PUBLIC CODE CHANGE PROPOSAL FORM FOR PUBLIC PROPOSALS TO THE INTERNATIONAL CODES 2012/2013 CODE DEVELOPMENT CYCLE

R408. Ventilation in under-floor spaces

Revise section R408.1 and following as modified

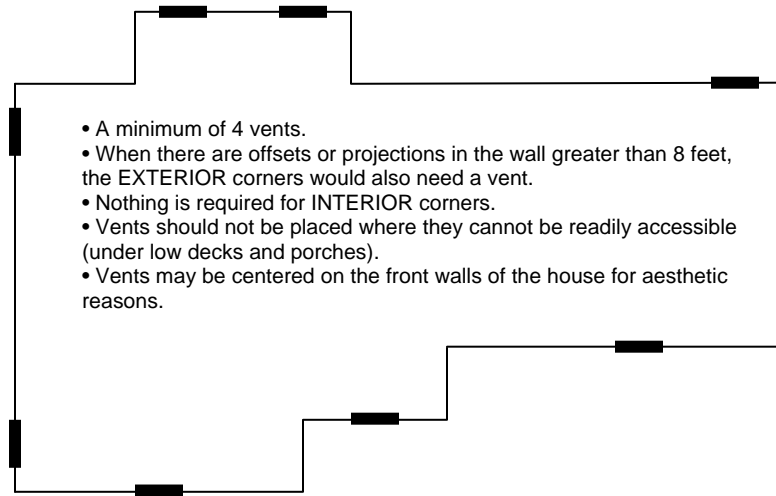
R408.2-1.1 Vented crawl spaces. Openings for under-floor ventilation. Ventilation openings shall be provided through foundation walls or exterior walls. The minimum net area of ventilation openings shall ~~not be less than at least~~ 1 square foot (0.0929 m²) for each 150 square feet (14 m²) of under-floor area. When a Class 1 vapor retarder material is used, the minimum net area of the ventilation openings shall be at least 1 square foot (0.092 m²) for each 1,500 square feet (140 m²) of under floor area space. As a minimum, there shall be ~~One~~four ventilation openings around the perimeter of the structure, one shall be within 3 feet (915 mm) on either side of each corner of the building. When the structure has a projection in the foundation greater than 8 feet, a ventilation opening shall be required within 3' of each outside corner. Vents shall be located in a readily convenient location, and not under low decks or porches. Vents may be centered on front wall projections for aesthetic reasons.

1. that no matter what the calculation shows, at least four openings are required for vented crawl spaces.
2. only one opening is required per corner – not one opening on each side of each corner (a frequent misinterpretation),

3. offsets in the foundation wall create more corners, and whether ventilation openings are required within 3' of each is always subject to debate. I think that the code intends to ventilate dead pockets which might occur at offsets...the 8' offset is a random number subject to discussion.
